TECHNICAL MEMORANDUM TM-1050

AN/SQS-23 (PAIR) SONAR LETTER REPORT (U)

22 September 1965

FIGURE 2
TASK 26

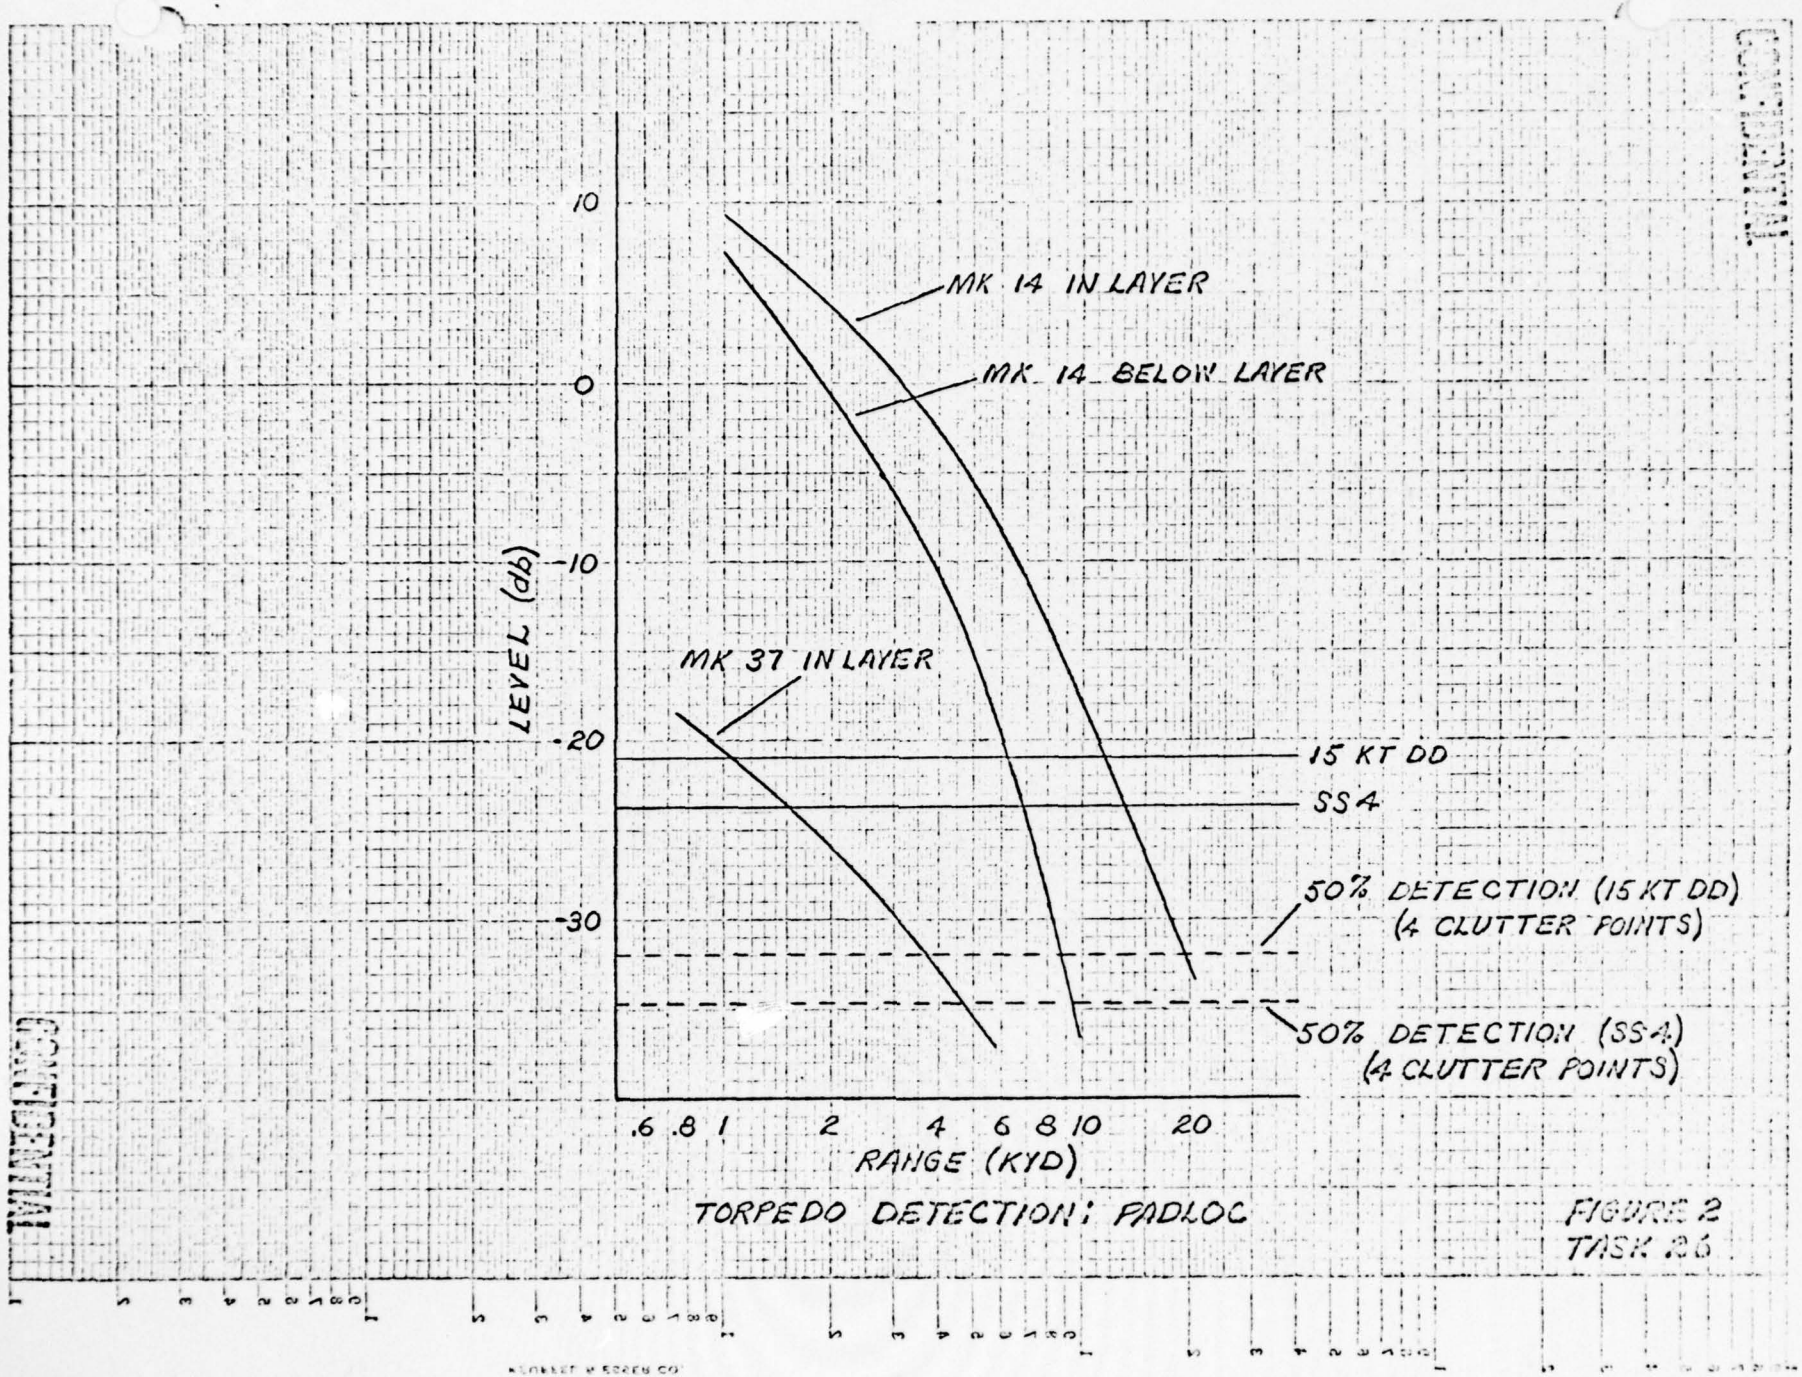
Detection of torpedoes with PADLOC is illustrated in Figure 2. The torpedo radiation levels for the MARK 37 and the MARK 14 used in the Sperry report and the noise levels for a 15-knot destroyer and sea state 4 are shown as well. The 50% detection level is also shown when the ship is self-noise limited and when detection is sea state 4 limited. This plot indicates

that passive detection to 4 kyd of a quiet torpedo is possible. These estimates of PADLOC performance are within one kiloyard of the examples in the Sperry report.

FIG. 1

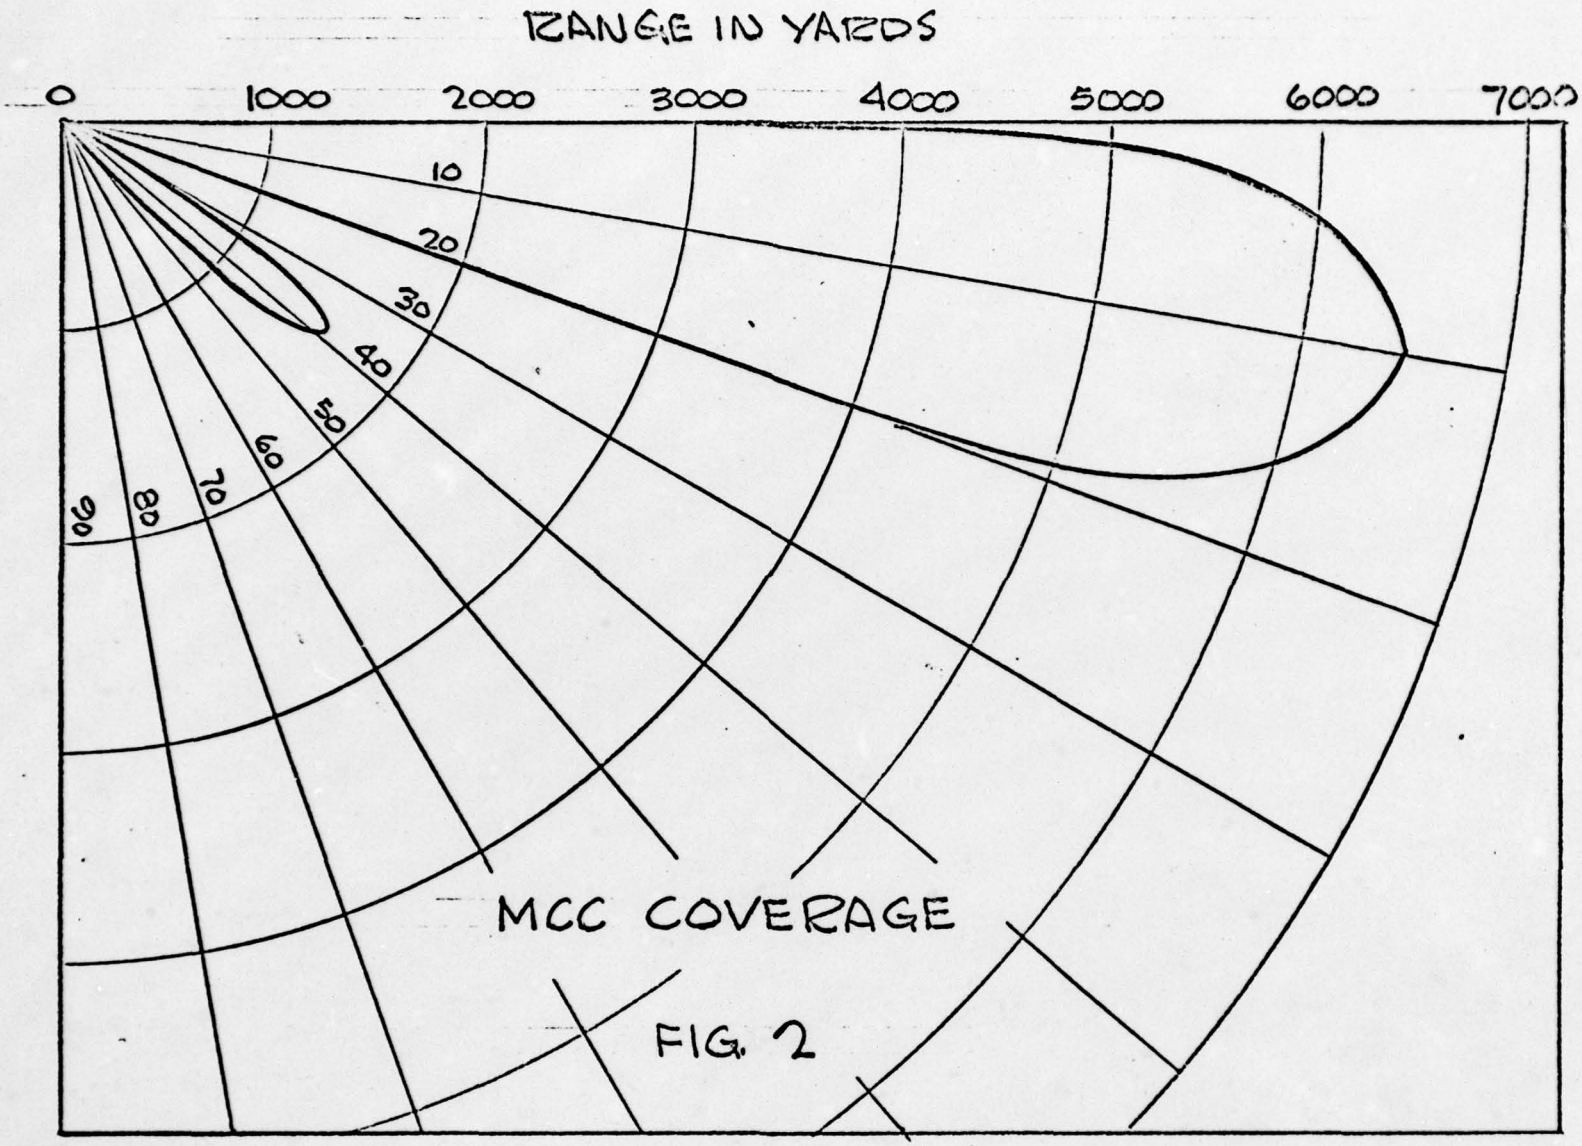
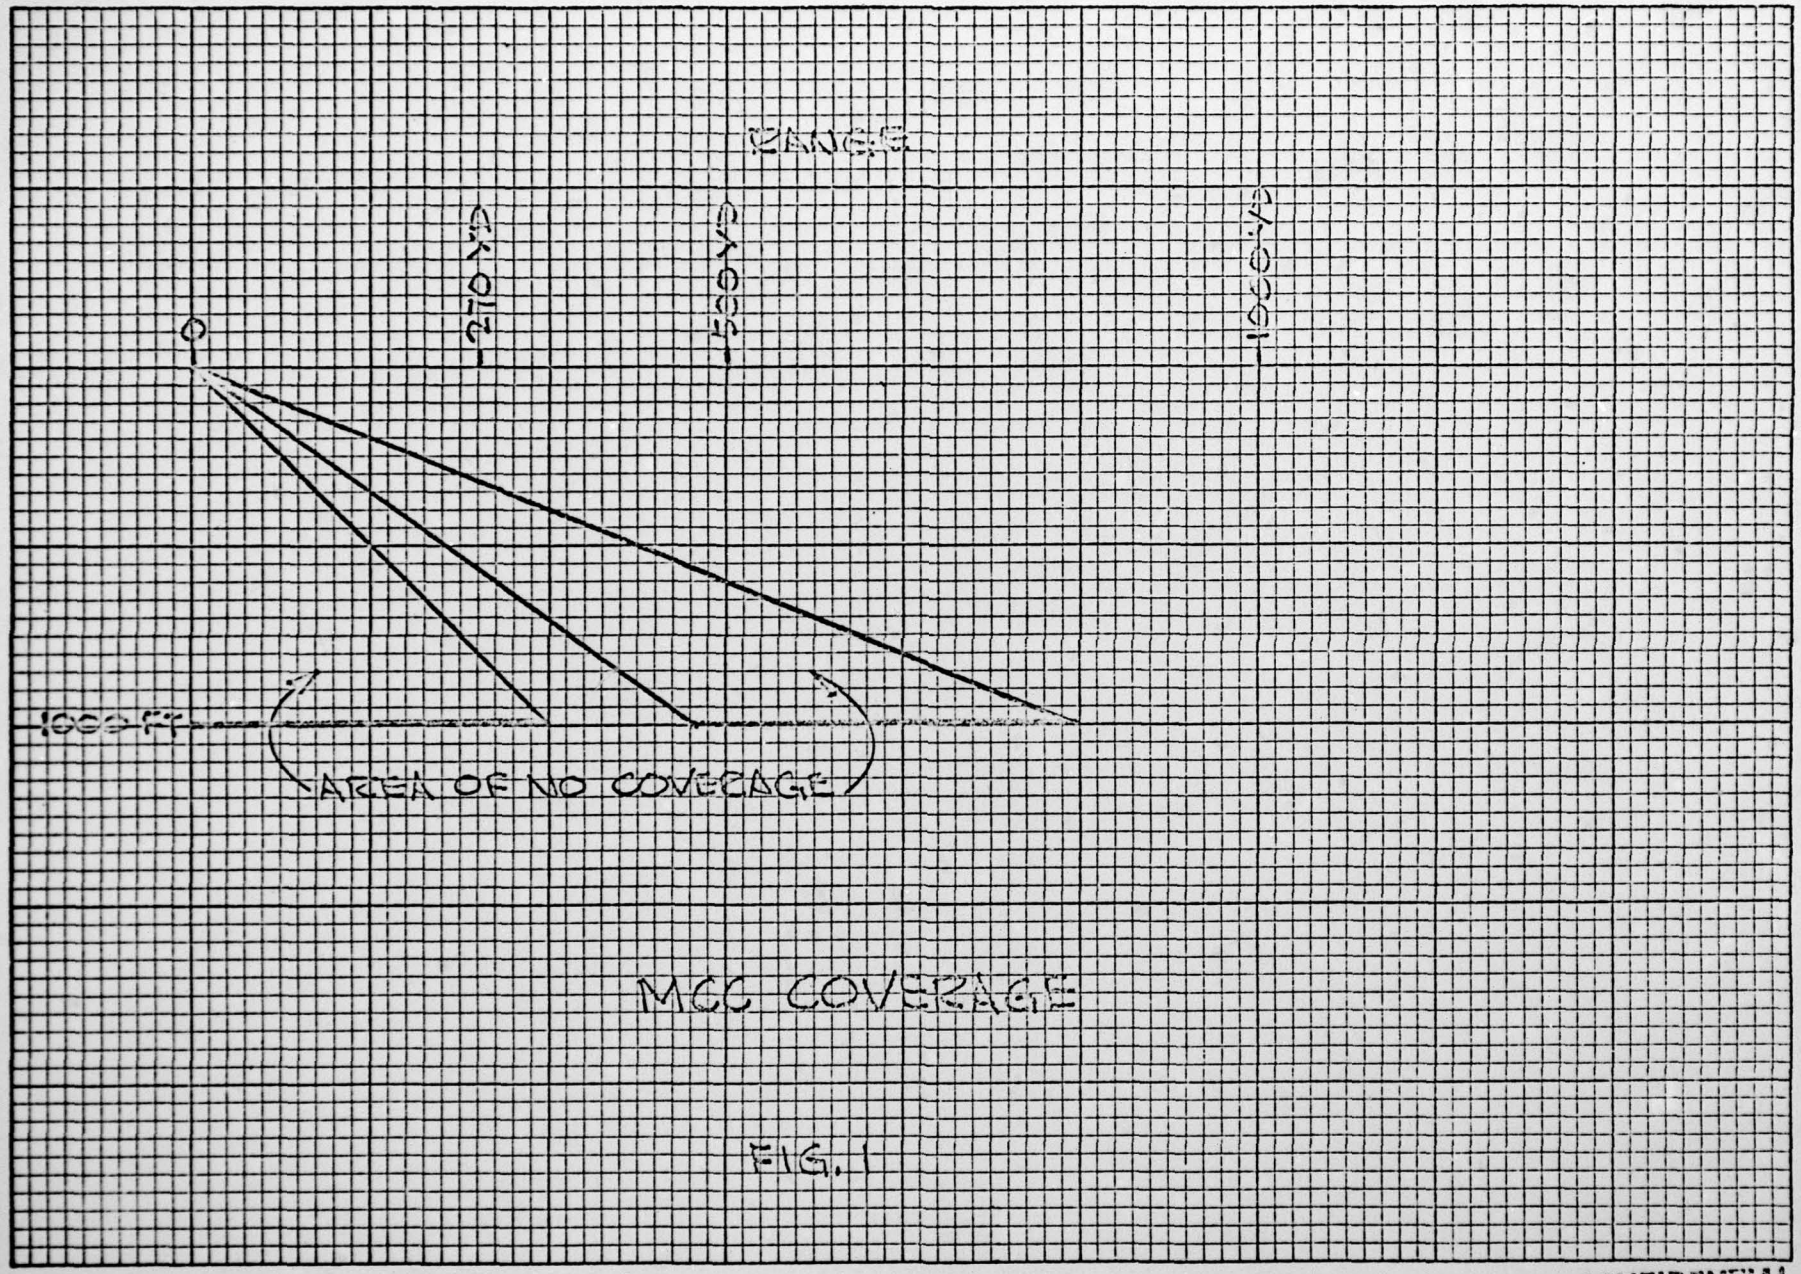
Figures 1 and 2 show the calculated areas of active transmit receive coverage and lack of coverage due to transmit and receiving beam patterns. The combined transmit-receive beam pattern was computed using the standard sonar equation and the following data:

Figures 1 and 2 depict areas of no coverage in the MCC Mode, therefore no tracking information would be sent to fire control for a target in these areas. Further studies on active and passive beam forming should be made to determine whether or not this condition is objectionable.
